Mining Permit Application Amendment Copperwood Volume I

Project I.D.: 17C050

Copperwood Resources, Inc.
Gogebic County, Michigan

Re: Amendment to MP012012 for the Copperwood Mine

FIGURE 2-1
MINING PERMIT APPLICATION AMENDMENT
PROPOSED MINING AREA BOUNDARY
GOGEBIC COUNTY, MICHIGAN

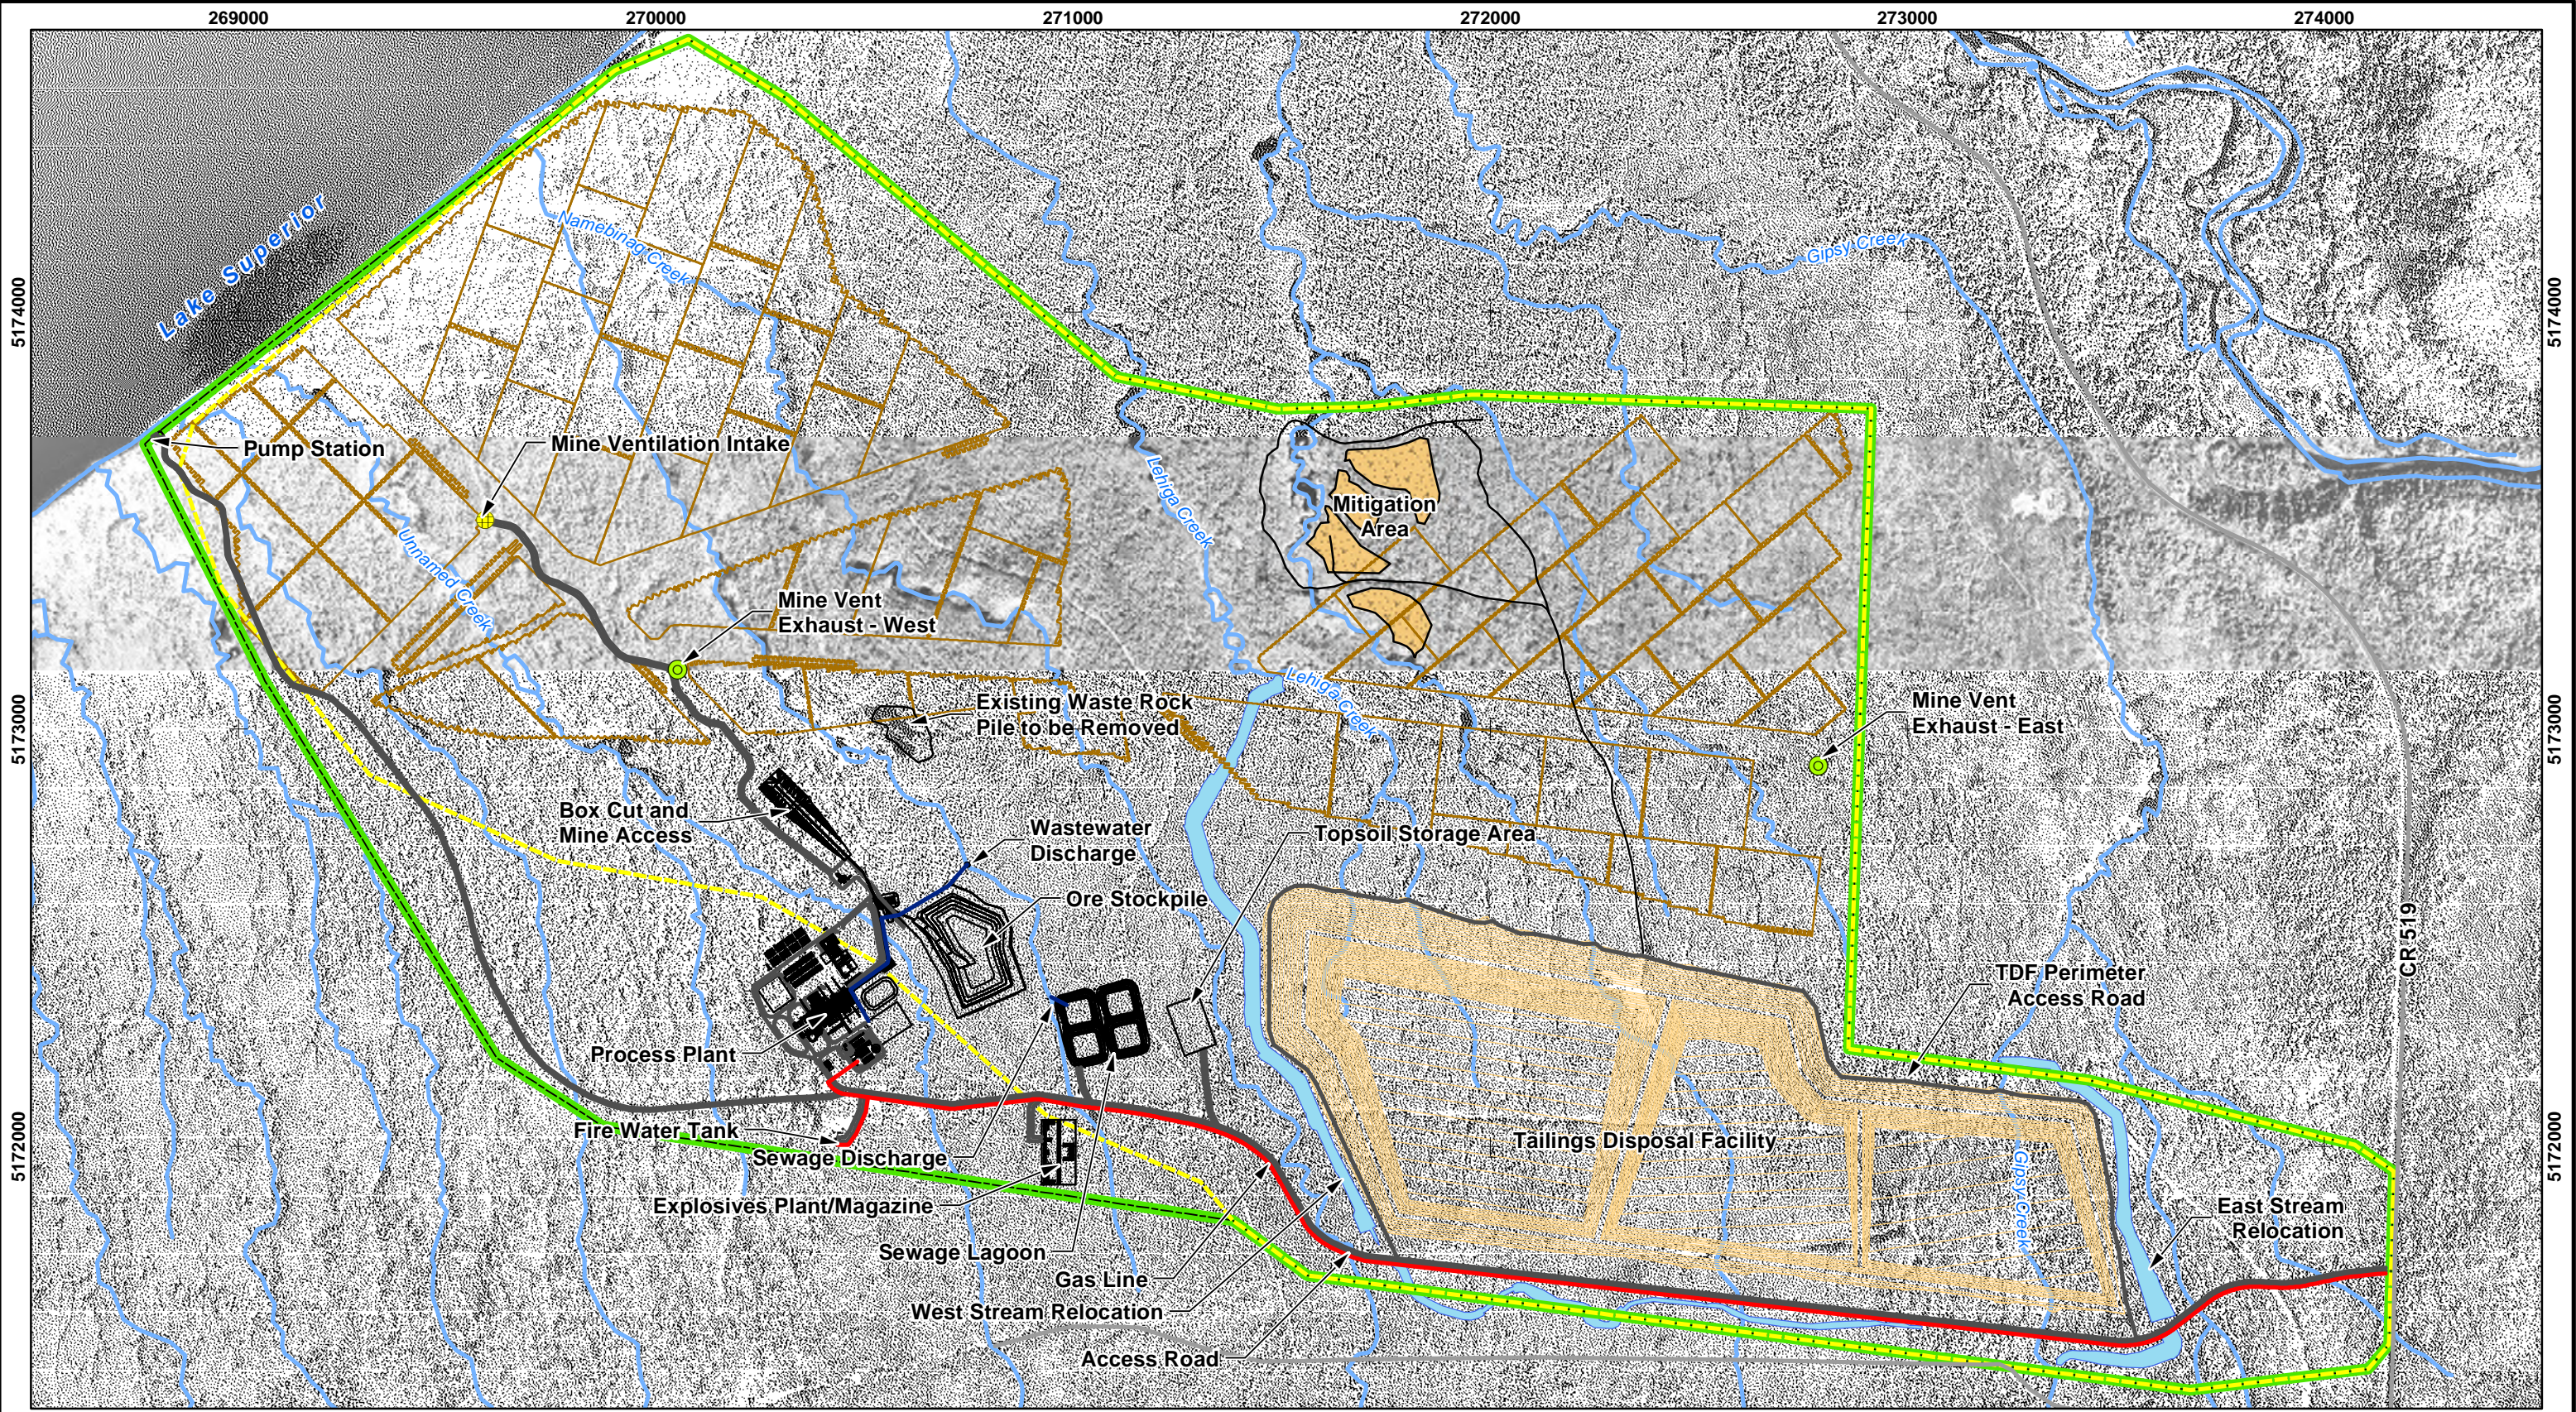
The defined Project mining area associated with this *Amendment* remains similar to the mining area presented in the original Mine Permit Application (MPA) (Orvana, 2011). The only change to the mining area occurs along the western portion of the mining area, where its boundary extends further to the southwest to account for the modified layout of the processing and support facilities. The proposed and former mining areas are shown on Figure 2-1.

COPPERWOOD RESOURCES	
FIGURE 4-1 MINING PERMIT APPLICATION AMENDMENT PROCESS PLANT AREA GOGEBIC COUNTY, MICHIGAN	
Scale: 0 30 60 Meters	Date: MARCH 2018
Drafted by: DAT	Project: 17C050

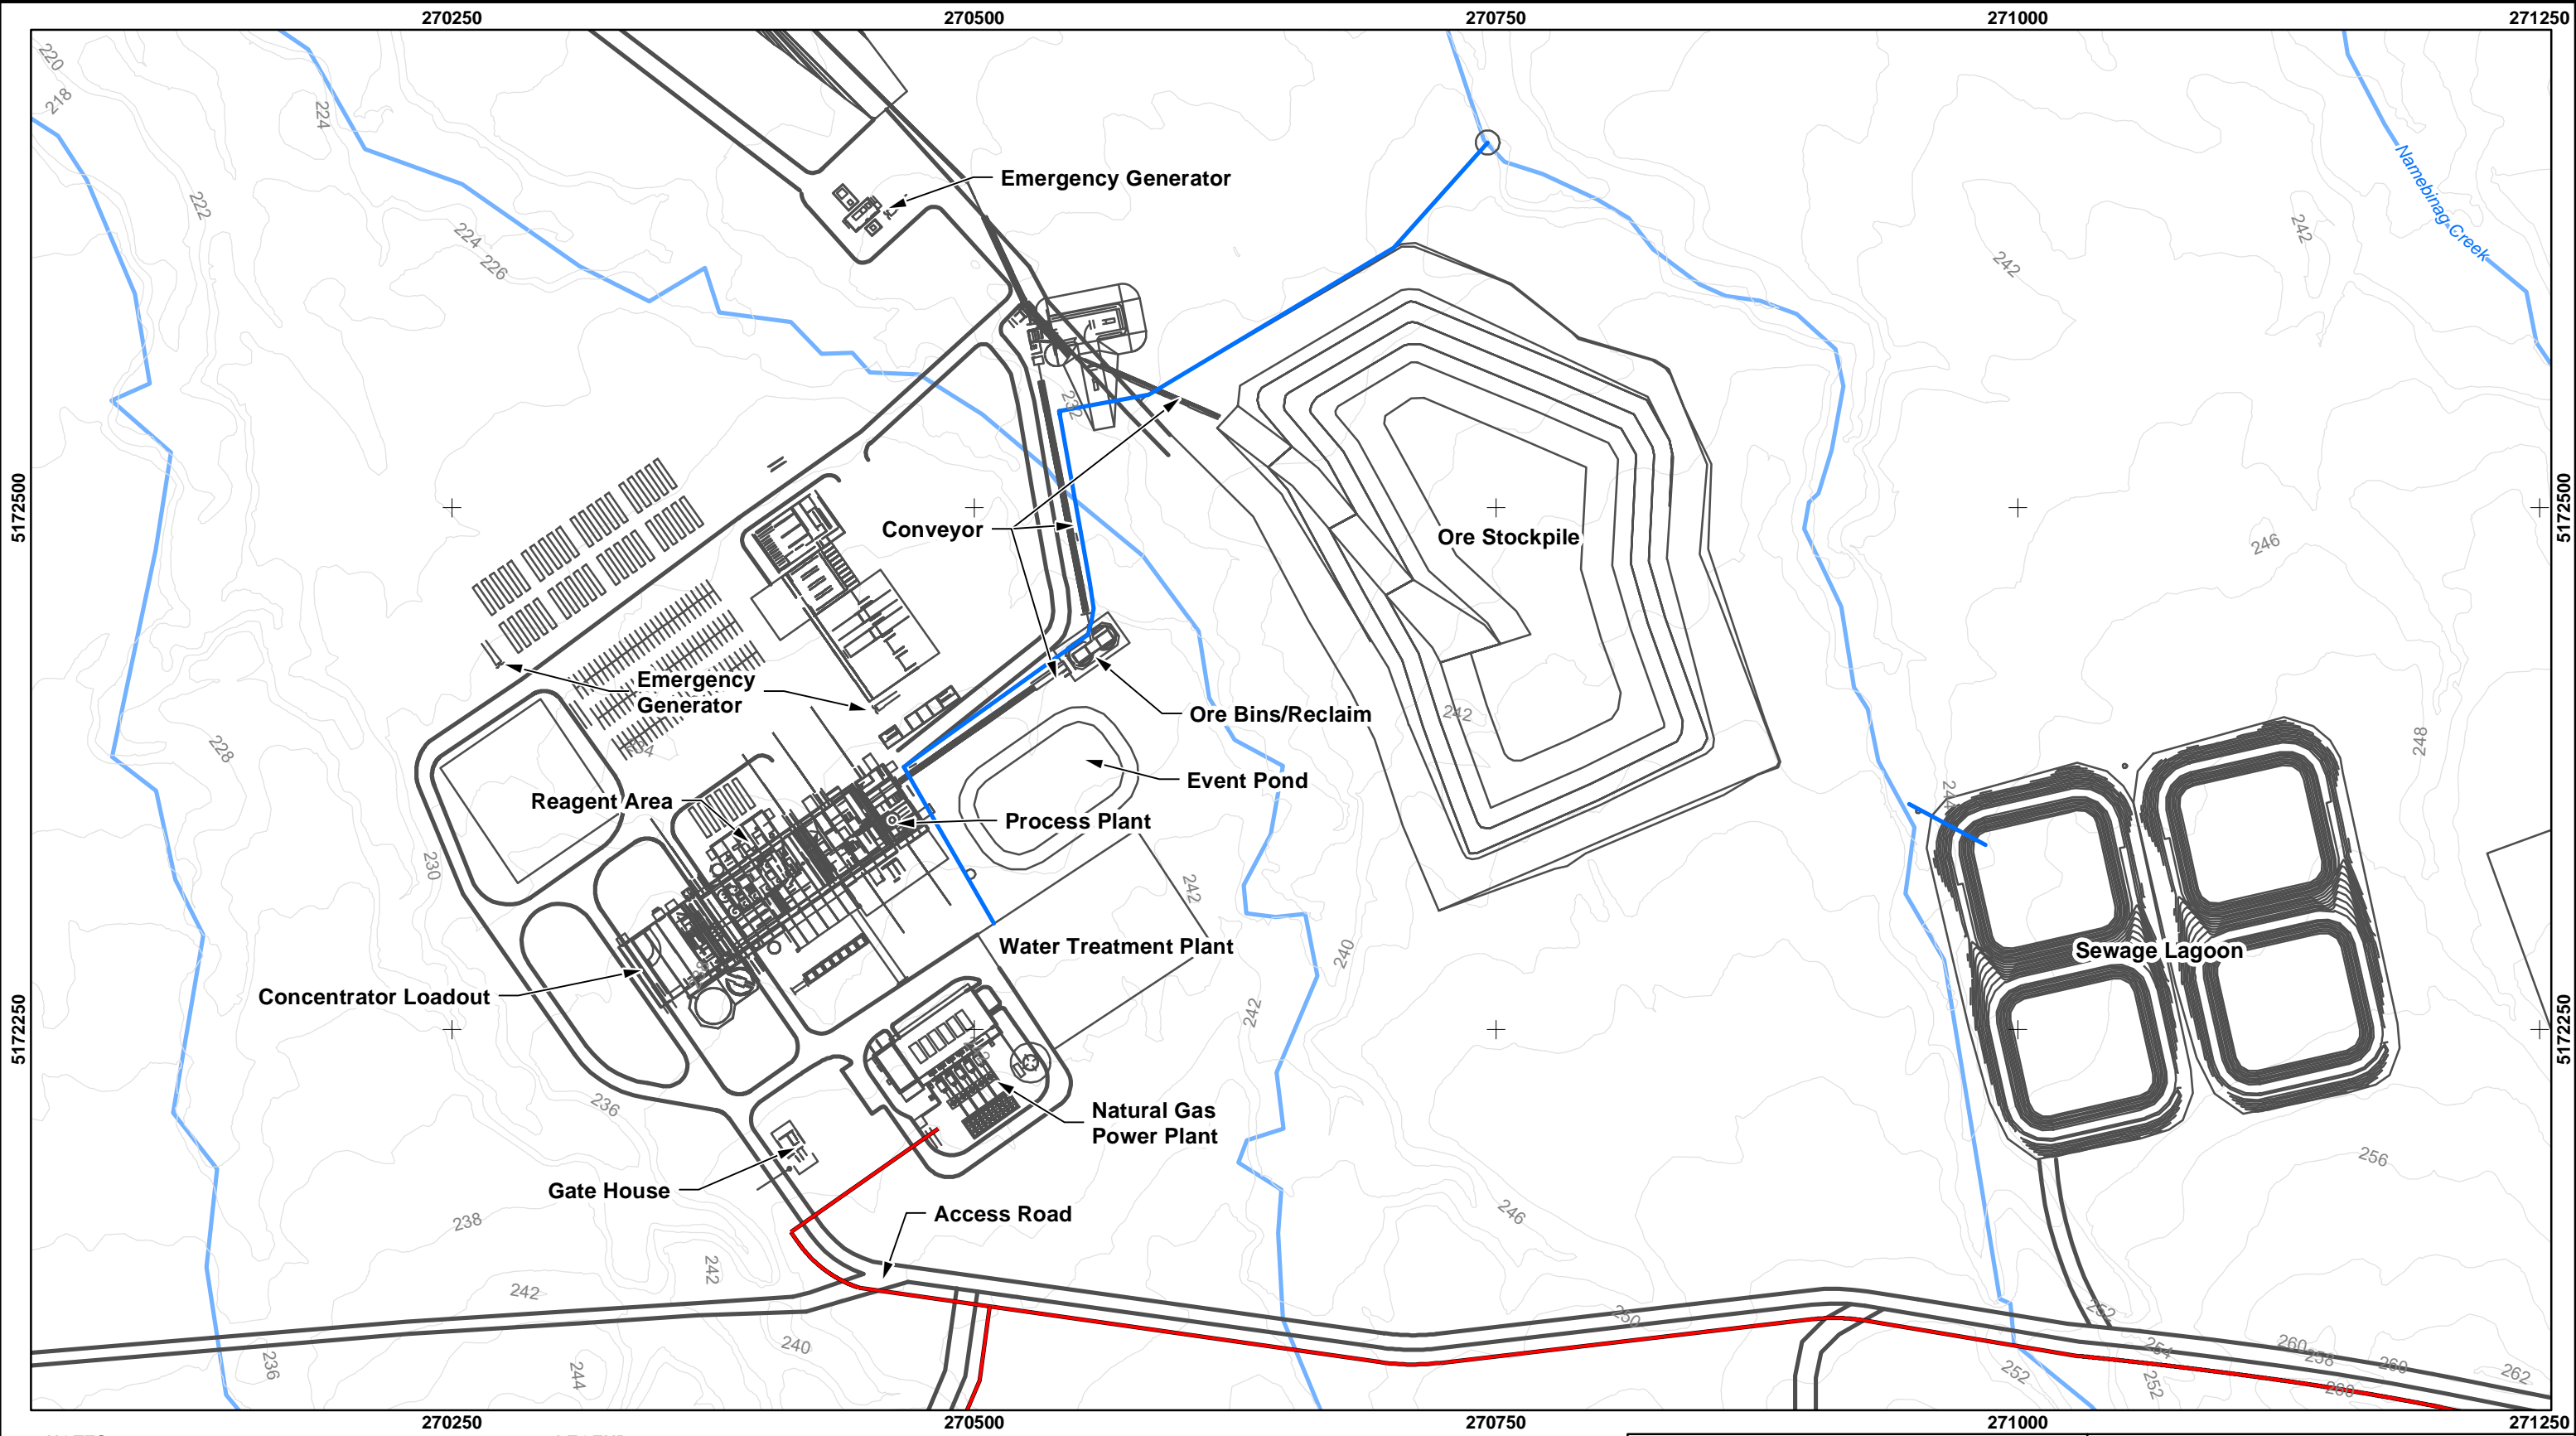
Surface facilities and operations described in the MPA remain valid. However, the location of most facilities have been modified, and two new facilities have been added to the Project (i.e.,

natural gas power plant and outdoor ore stockpile). Proposed locations of Project surface infrastructure across the site are shown on Figure 1-2 and surface facilities located near the process plant are shown on Figure 4-1. The surface facilities and operations that will support the Project include the following:

Electric service is not readily available from a utility at the Project location. Electrical demand of the Project will be met by installing an onsite natural gas power plant consisting of five natural gas power generators. The generators will be Wartsila Model 12V34SG units. Each generator is rated at 5,564 kilowatts (kW) at 100% load. During operations, four generators will operate at any given time, with the fifth generator available as a reserve. Generator use will rotate between the five units during the course of one year. The generators will provide electrical power to the facility 24 hours per day, 7 days per week, 365 days per year. To achieve low emissions, each generator will be equipped with both a Selective Catalytic Reduction (SCR) system for controlling emissions of nitrogen dioxide (NO₂) and Oxidation Catalyst for reducing emissions of carbon monoxide (CO) and volatile organic compounds (VOC). The location of the power plant is shown on Figure 4-1.

The facility will also have three diesel-fired emergency generators that will be used as back-up power for the facility in event of a power outage. One of the back-up generators (1,000 kW) will be located near the underground mine access box-cut, while the other two generators (500 kW each) will be located near the process plant. Locations of each emergency generator is shown on Figure 4-1.

FIGURE 4-2
MINING PERMIT APPLICATION AMENDMENT
INTAKE VENTILATION RAISE
CONCEPTUAL DESIGN
GOGEBIC COUNTY, MICHIGAN

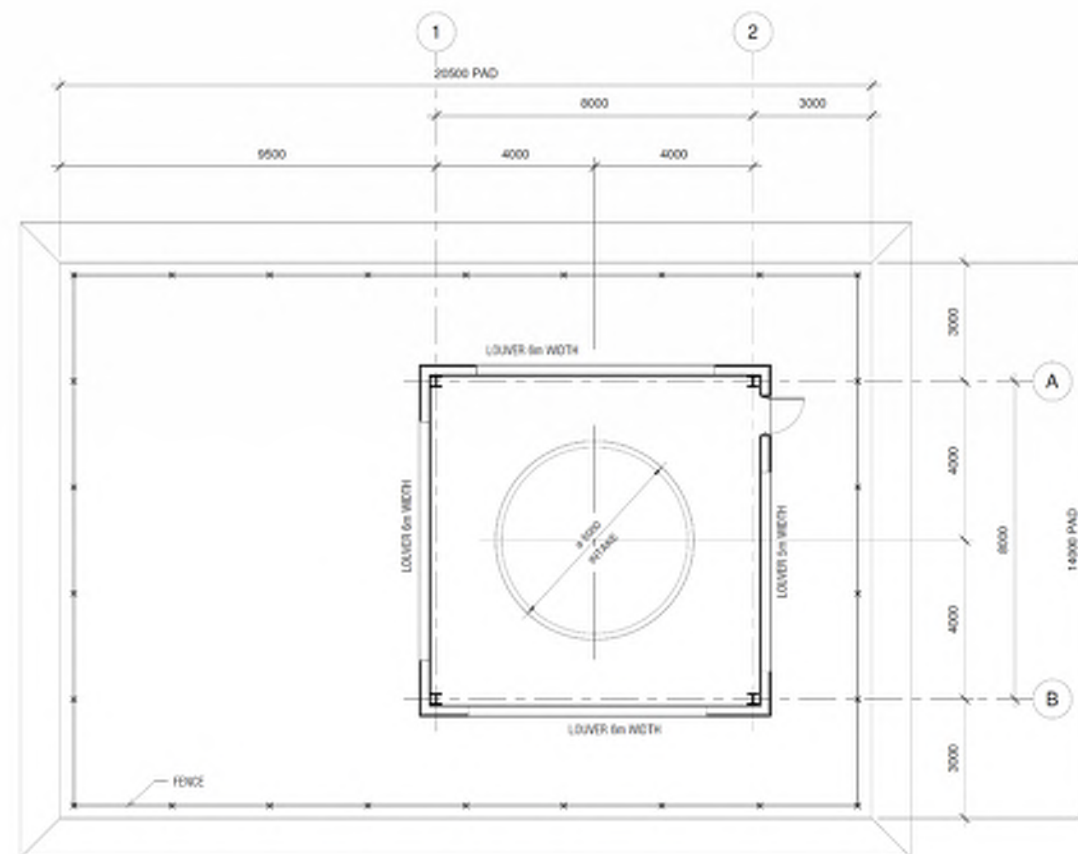
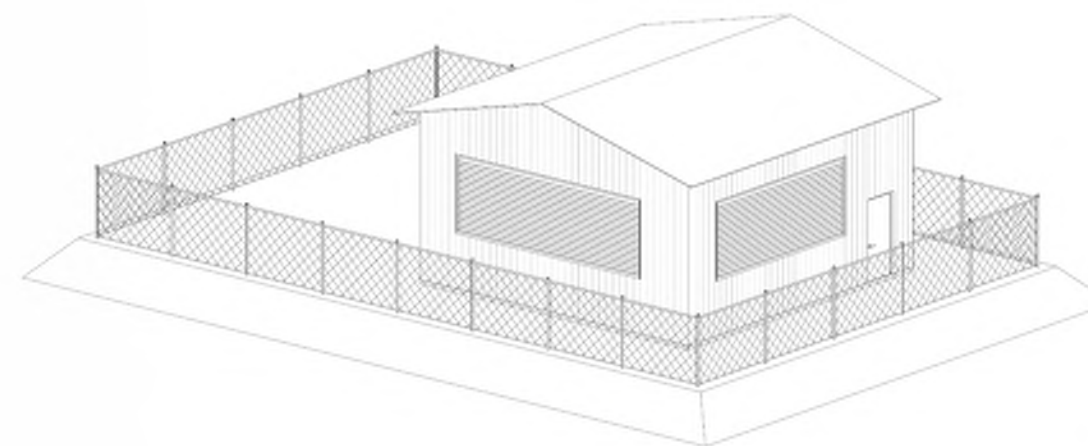
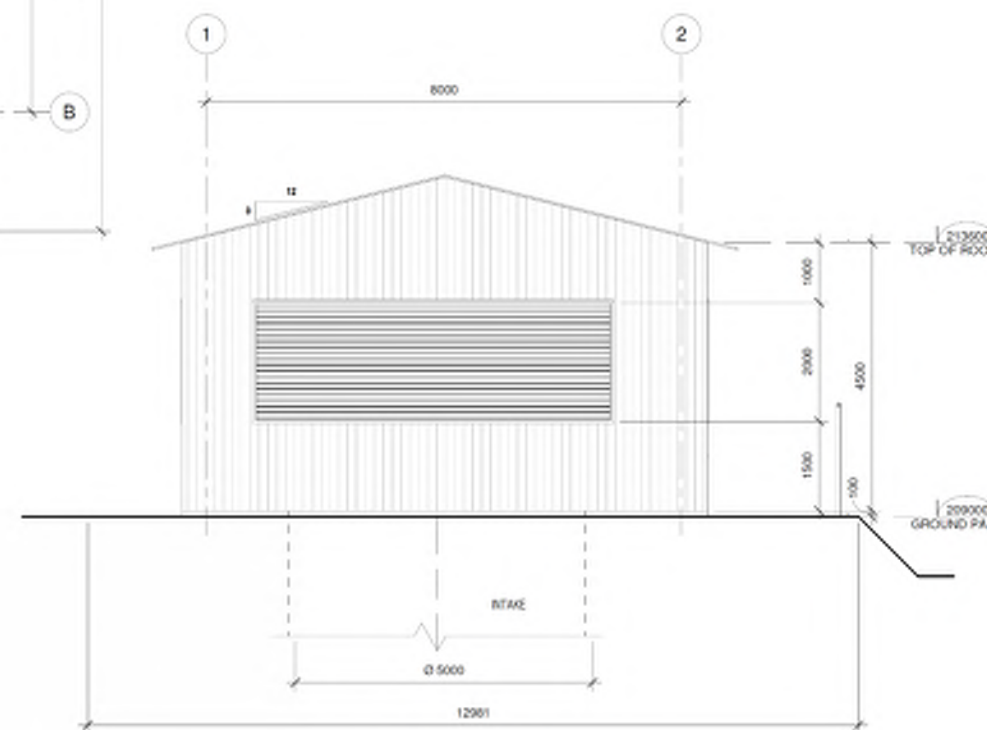
One intake ventilation and two exhaust ventilation raises will be required to support the underground mine ventilation requirements. The location of these three ventilation raises are shown on Figure 1-2. The intake raise is on uninhabited commercial forest property currently owned by the Hancock Natural Resource Group and will require some type of use agreement under mineral lease law. The exhaust raises are both on property owned by Copperwood.
